NVSCU # 1
8 hr Spacing
Correspondence

Subject: Net Oil Computer Status

Table No. 1
North Virden Scallion Unit No. 1
Notice of Application
Interested Parties

FIG NO.4

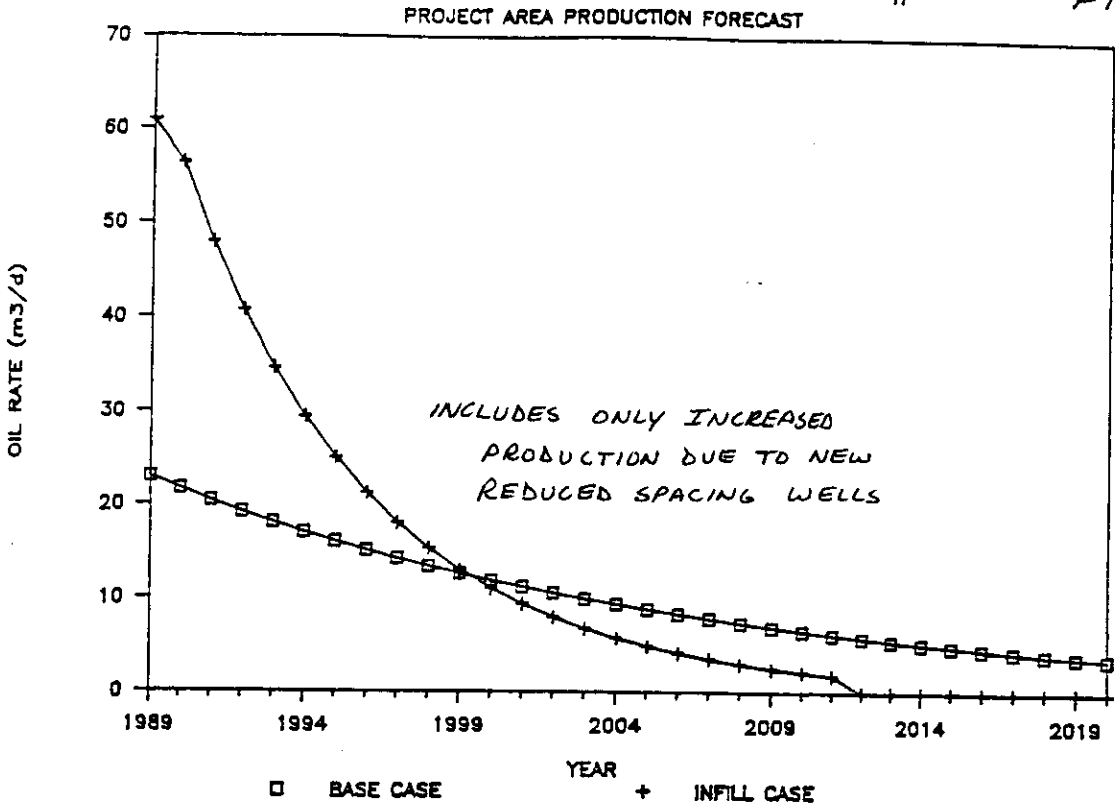
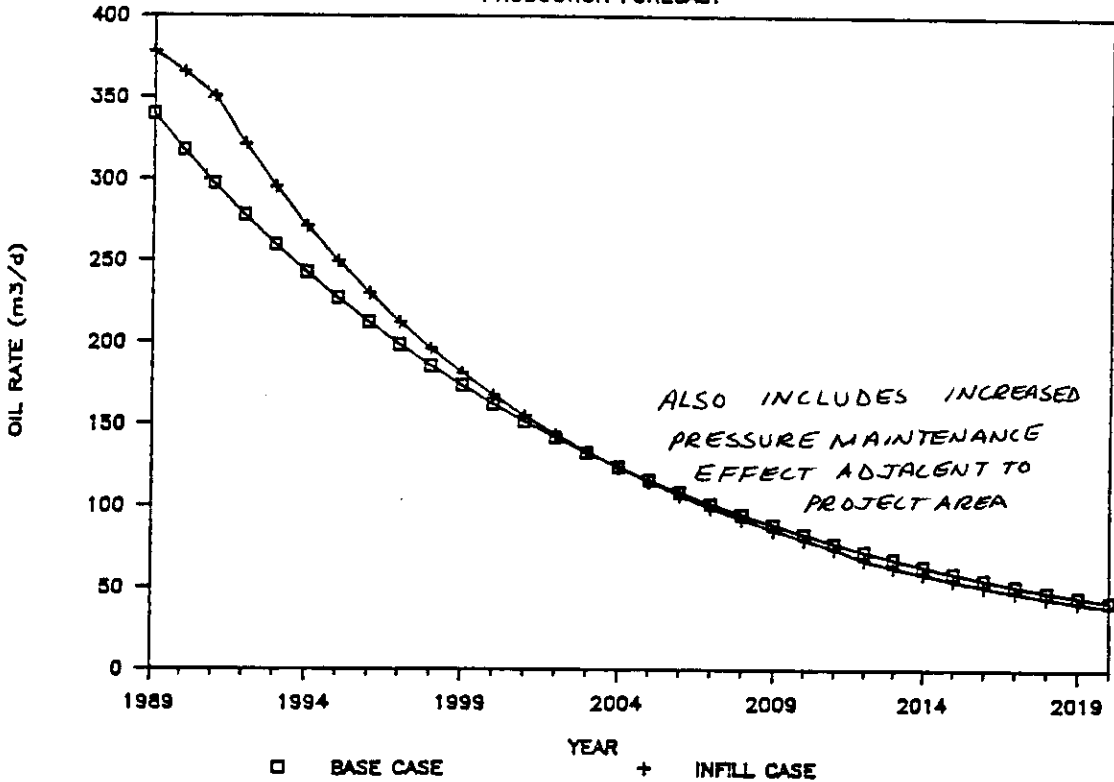
Chevron's methodology for estimating incremental recovery has been examined in detail. While there are some minor areas that require clarification, the production predication (Fig. No. 4) appears to be reasonable.

Assuming the validity of the production forecast (Figure No. 4) the net effect of these factors is to increase Crown revenues by a total of 7 240m³ over the life of the project. Chevron has expressed the net benefit to the Crown as a volume rather than a dollar volume to enable factoring out of oil prices.

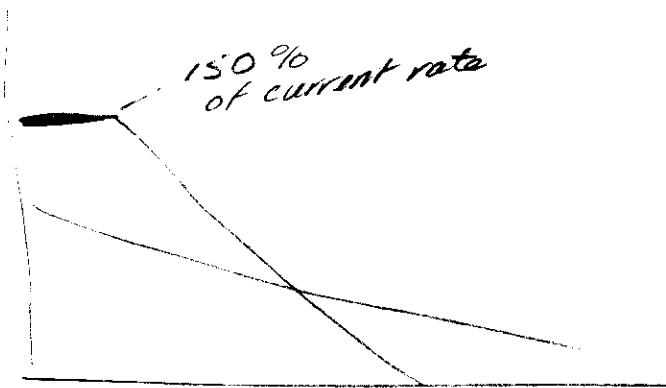
- no major change in decline rate of original wells when 16C-22 drilled

- some of production response for pattern not attributable to 16C-22 - may be measurement recovery, pressure

- 8.0% decline before 16C-22 reasonable
